BIM RESPONSES TO COMMENTS FROM REGULATORY/GOVERNMENT AGENCIES

Response to Comments - December 9, 2007

Re: October 18th, 2007 Comments on 2BB-MRY0710/Wastewater Management Plan/Mary River Project/Baffinland Iron Mine Corporation

**Re: 2BB-MRY0710 Mary River Project Baffinland Wastewater Management Plan (WWMP)
– Response to Reviewers Comments**

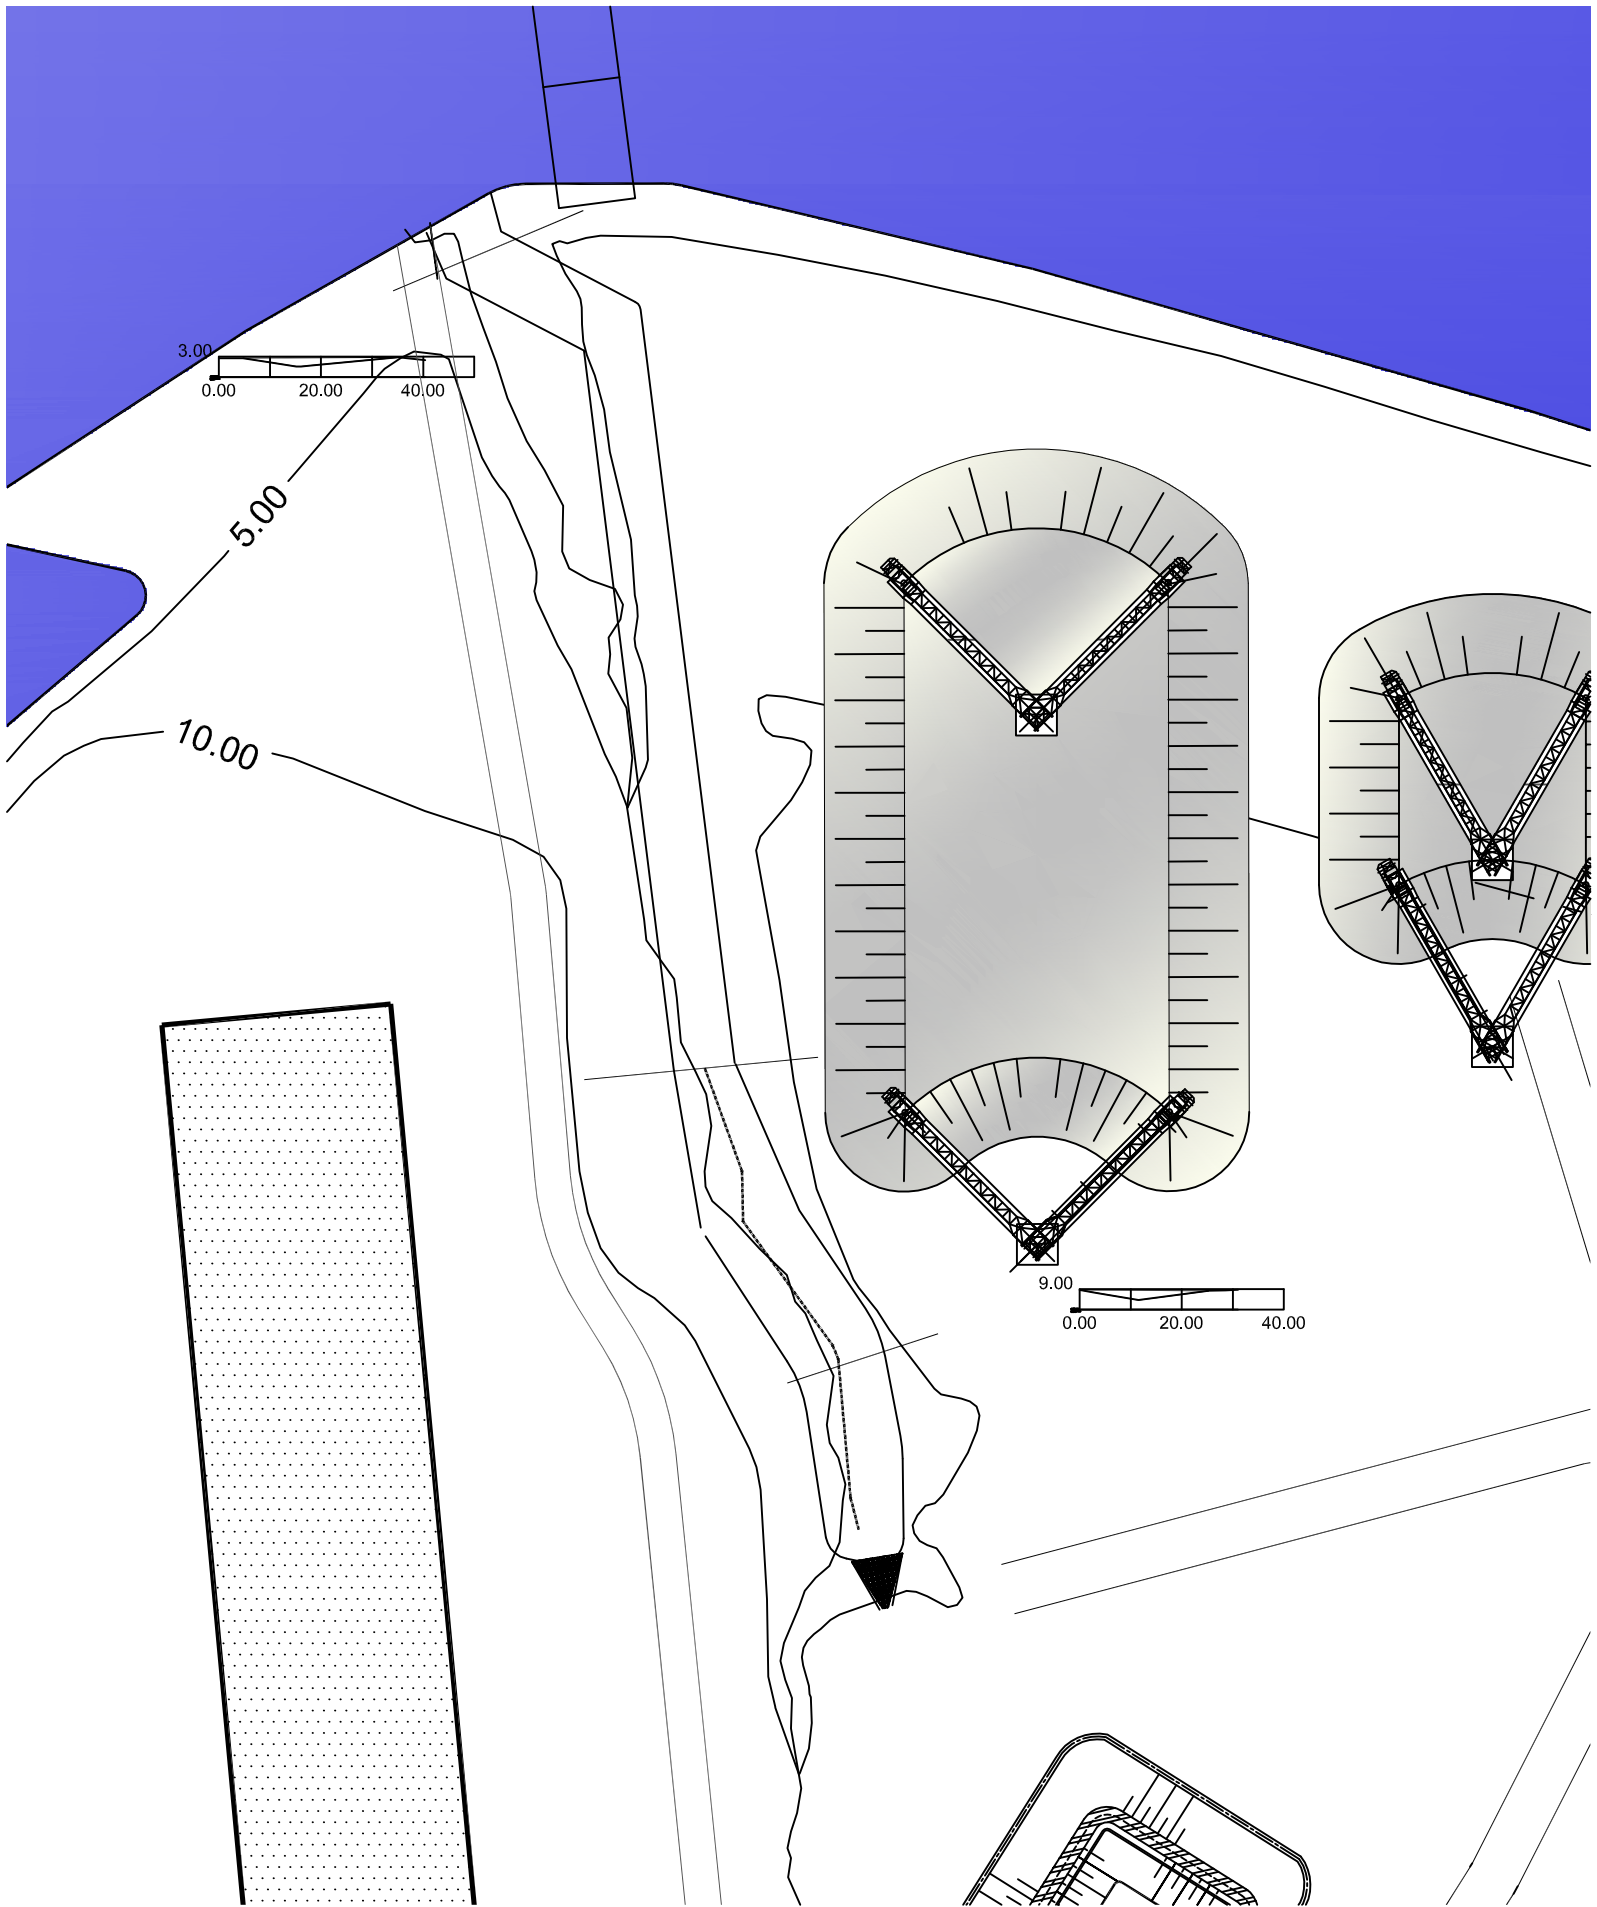
5. **The Wastewater Management should include a detailed description of the drainage ditch situated at the Milne Inlet site. Section 9.3 refers to this ditch as being large, wide and several hundred meters in length. Approximate dimensions of the ditch, observed vegetation, and recorded water levels would allow a better understanding of the receiving environment.**

A detailed description of the ditch is included as a Figure 2 attached to this letter. The dimensions of the ditch are as follows: average width of the drainage ditch is 15 meters, average depth (not water levels but depth of land) is 1.9 meters and approximate length is 275 meters.

HEAT TRACE PLAN AND DETAILS

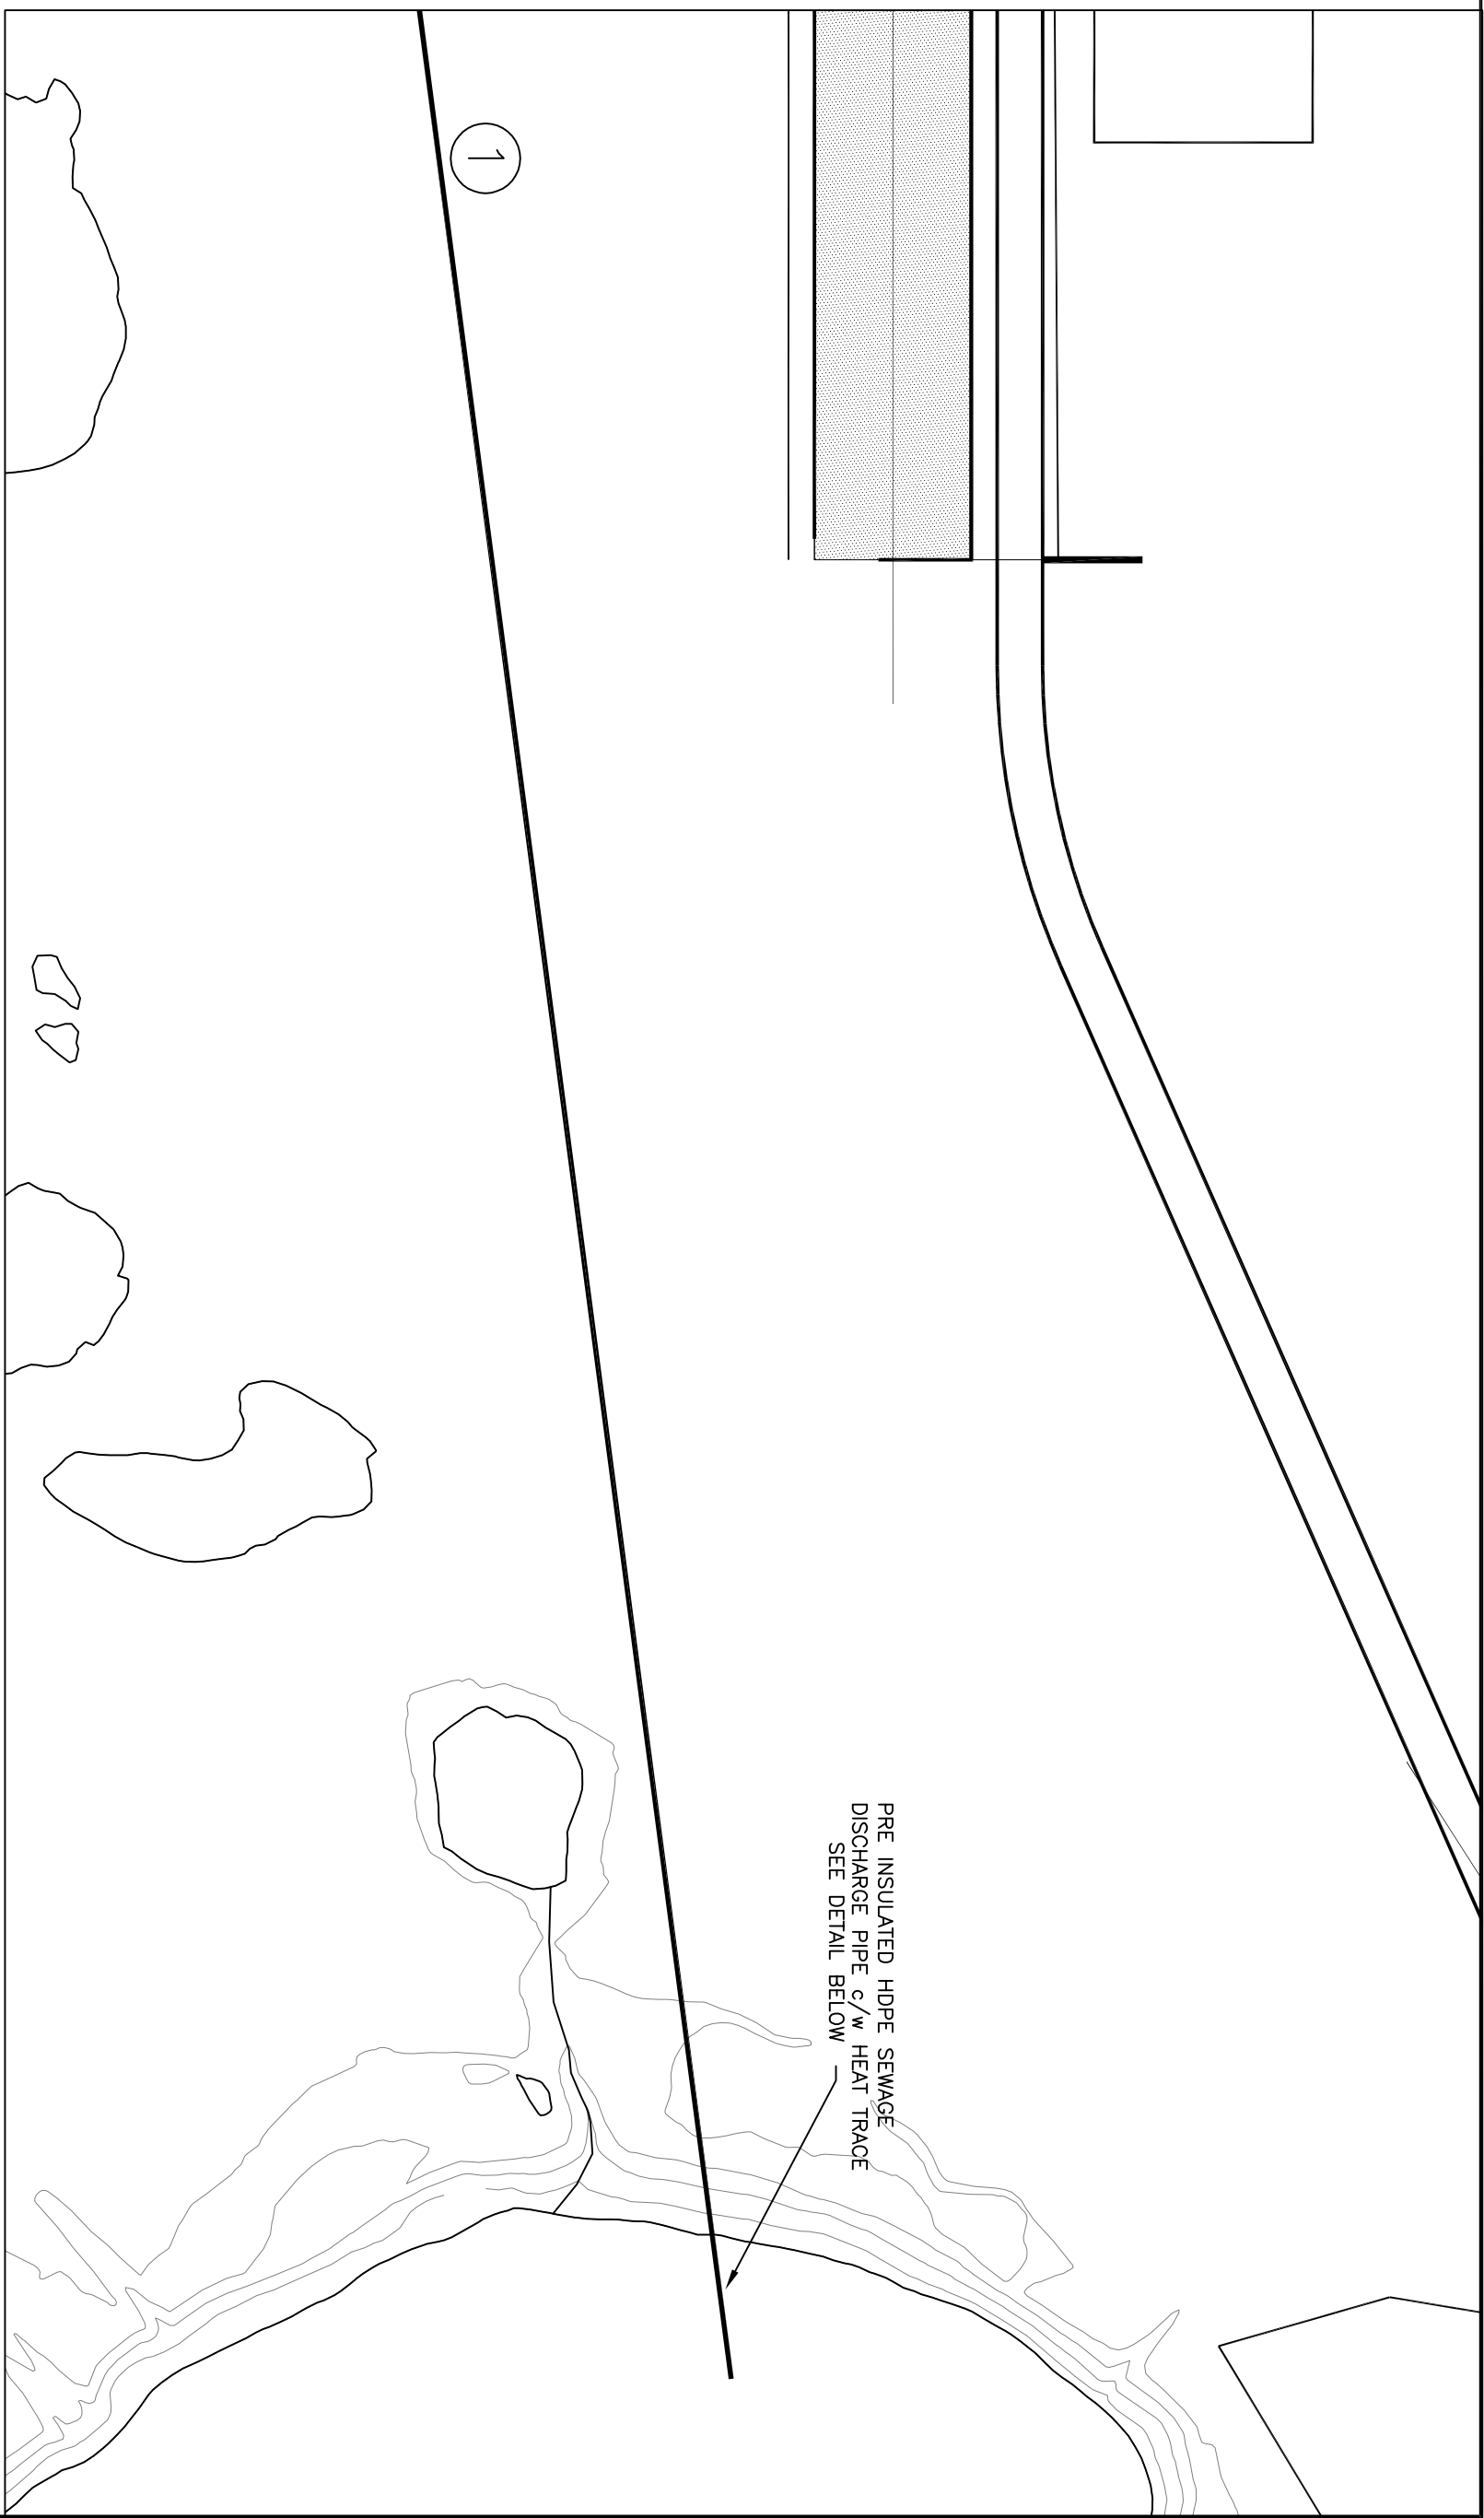
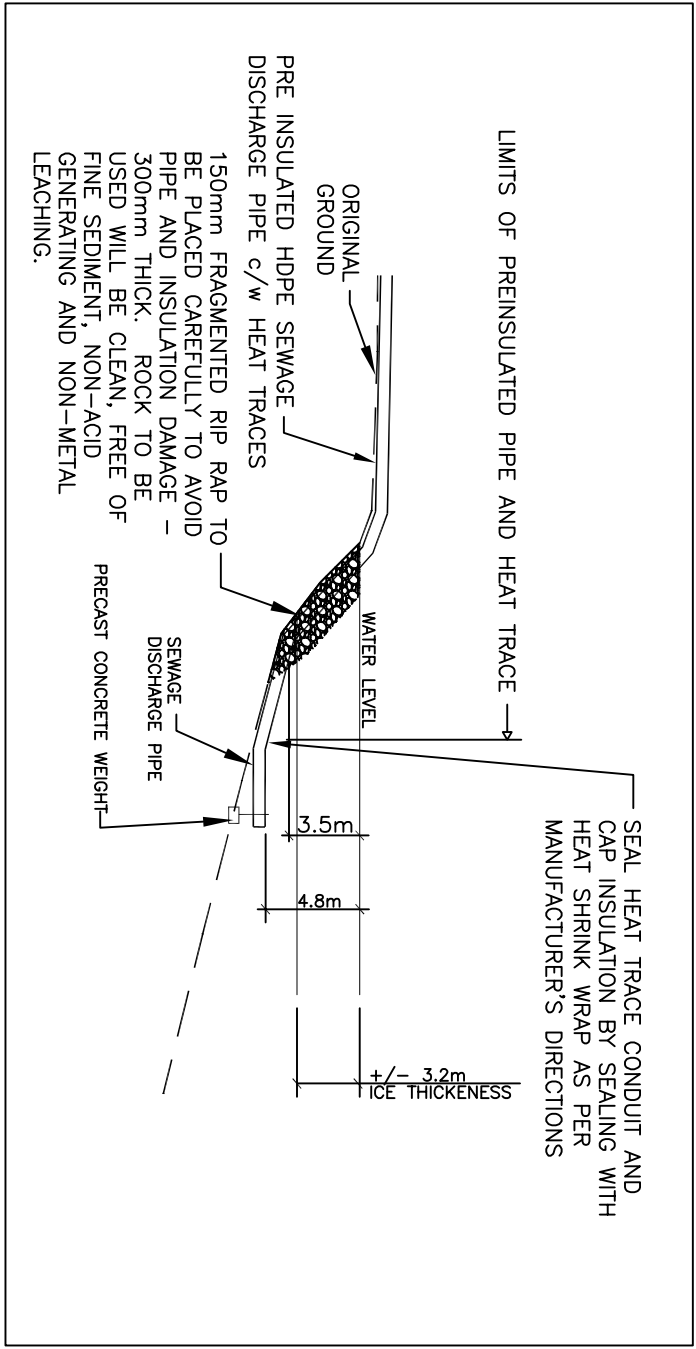
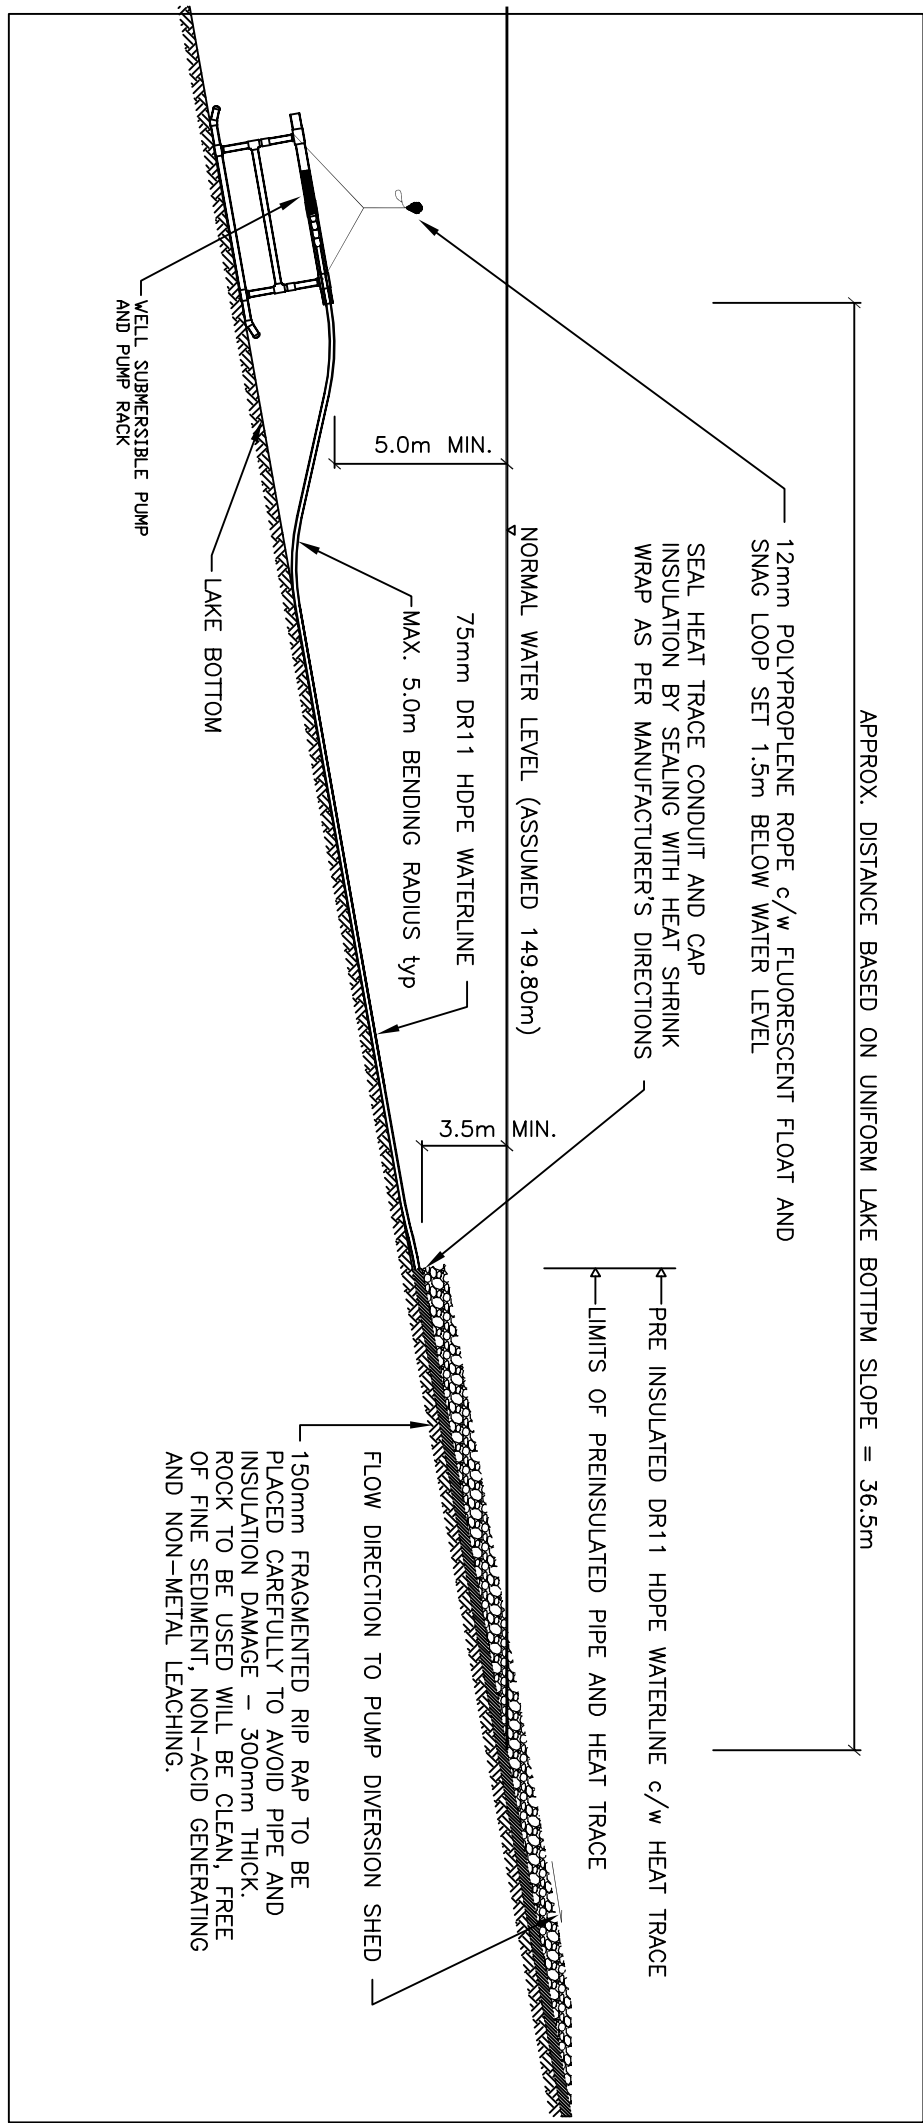
- 2. The proponent to explain how the design of the Mary River Camp's effluent discharge pipeline will prevent the freezing of treated wastewater en route to Sheardown Lake. Section 3.2 of the submitted Plan states the freeze protection measures include having a pipeline constructed of high density polyethylene, polyurethane insulation, and a heat traced electric thermocable. The proponent should explain why it intends to have the portion of pipe within the lake's ice depth to be insulated but not heat traced and why the portion of the pipe below 4 meters depth of the typical water/ice surface will be un-insulated. Having insulation and heat tracing throughout the entire discharge pipeline may be a prudent freeze protection strategy.**

An upgraded design of the sewage outflow pipe into Sheardown Lake includes the heat tracing and insulation to 300mm below the nominal ice level. This will prevent the freezing of the treated wastewater discharged into Sheardown Lake. The attached Drawing Number E104-R3 illustrates the new design of the sewage outflow line at Mary River and will ensure that a freeze protection strategy is in place.
